Service Campaign 63-01

AFFECTED: Certain 2013 Winnebago Adventurer, Journey, Tour and Itasca Suncruiser, Meridian and Ellipse Model Motorhomes Equipped With a Lippert Bed Lift Control Module

SUBJECT: Bed Lift Control Module Replacement

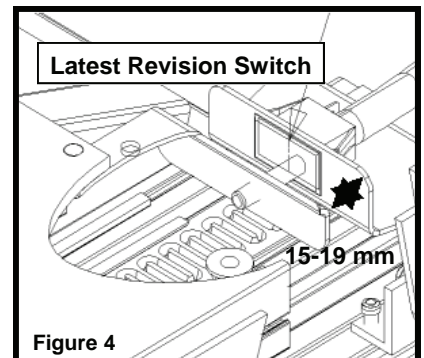
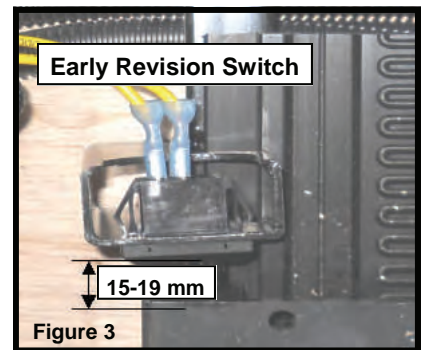
1. Locate the LCI bed control (15001-A) under the bed platform at the foot of the bed. (Figure 1) Disconnect the positive wire, ground wire, up, down and motor connector wiring. (Figure 2)
2. Install new revision control (15001-B). Connect motor wires, up, down, positive wire and then ground wire. (Figure 2)

1. To enter calibration mode, hold the 'Configuration' button down for 5 seconds. (Figure 2)
2. Use the wall switch to run the bed down until you hear the motor start to labor. Avoid racking the bed frame.
3. Press the button inside the 'configuration' window, this saves the bottom position in memory.
